DISCUSSION ON THE LHC DS COLLIMATORS (22/09/2010)

Elias Métral and Marc Timmins

DS collimators proposal

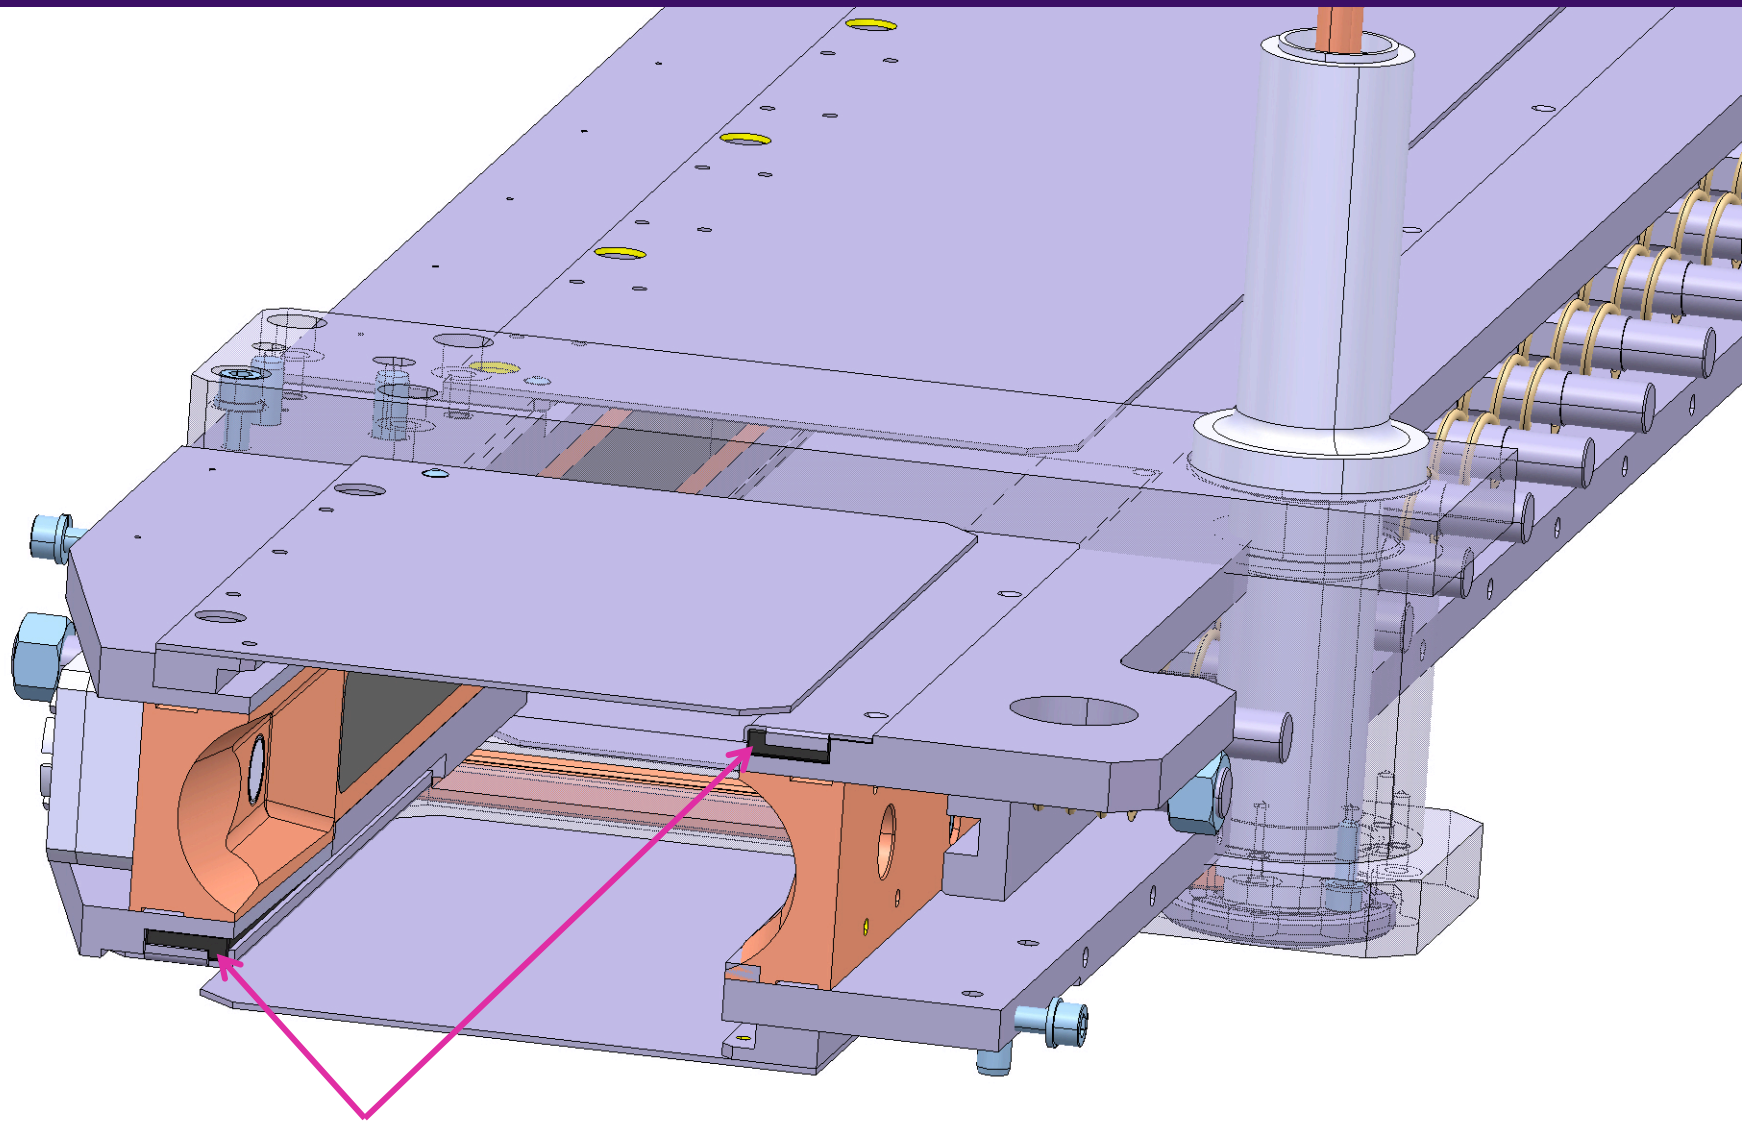
- ◆ **Question: The design is based on the one for the Phase 2 collimators => Ferrite on top and beam screen on bottom on one jaw, and opposite for the second jaw (see next slide). Can we have the 2 ferrite plates on one jaw and the 2 beam screens on the other (this issue arises due to the cryo line which complicates the mechanical design)?**
- ◆ **Answer: Yes.**
- ◆ **Once a new design is ready, we would like the drawings to perform (quantitative) electromagnetic simulations**

Pictures from the Phase 2 design (1/2)

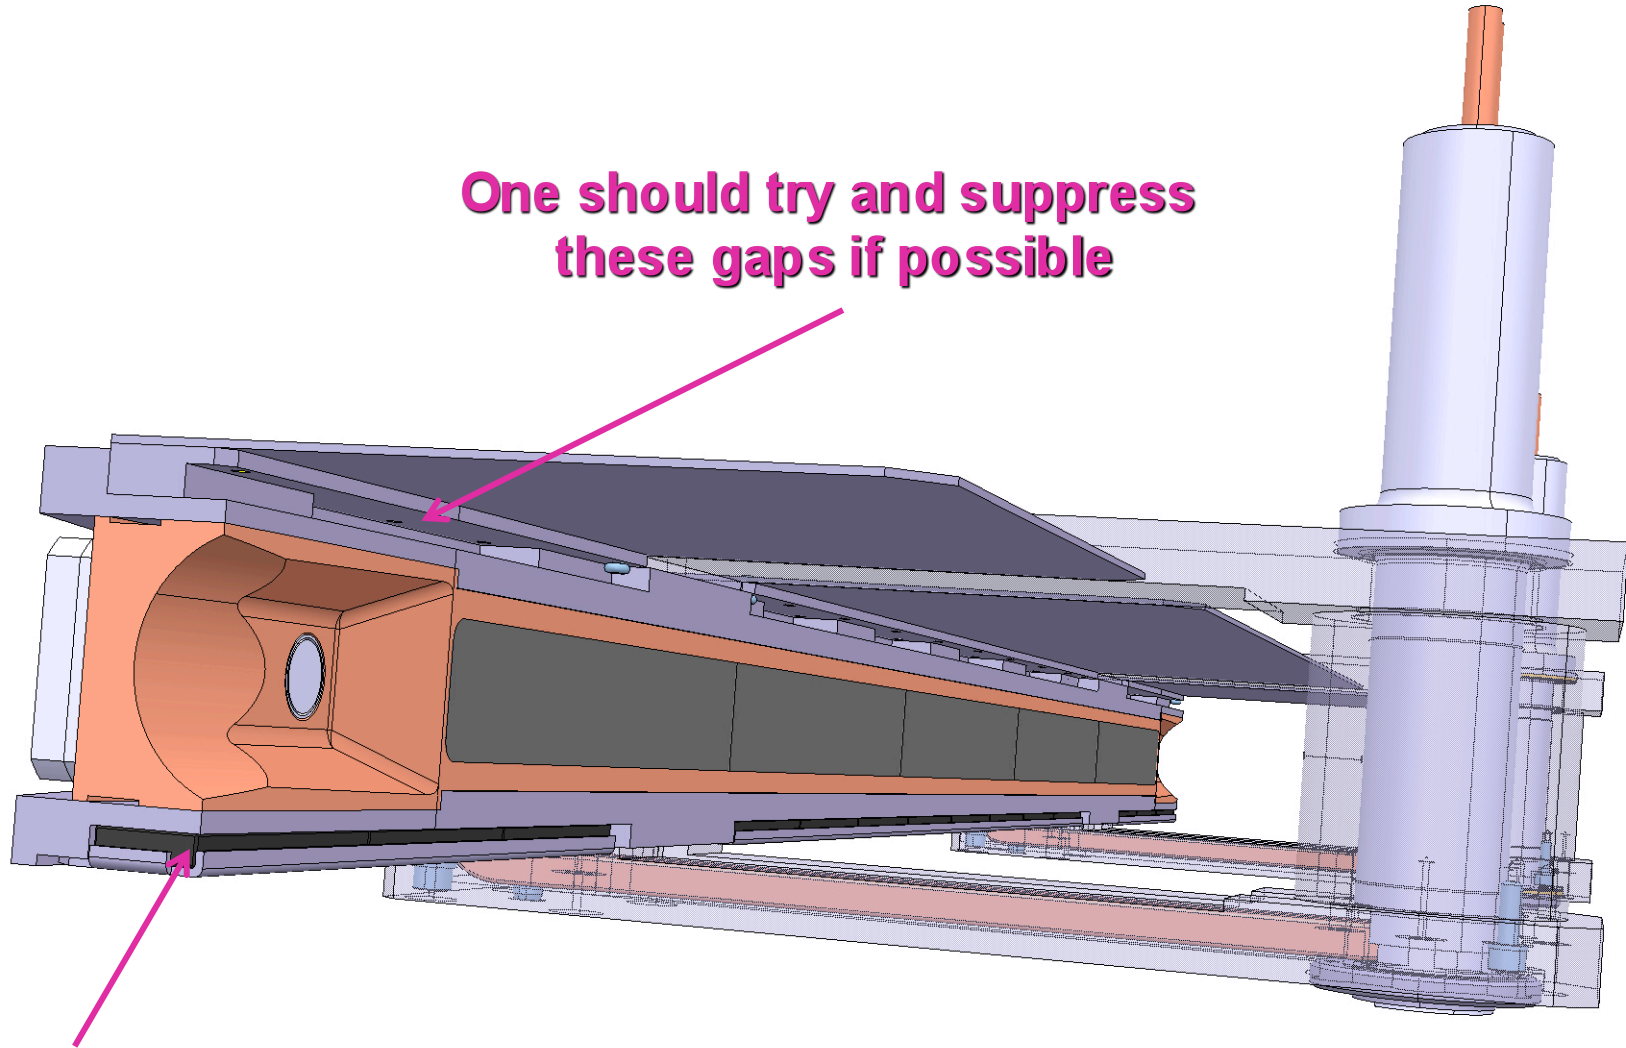
One should try and suppress these gaps if possible

Ferrite (6 mm height but only 3 mm visible by the beam due to the stainless steel box) => Try and increase the visible height of the ferrite
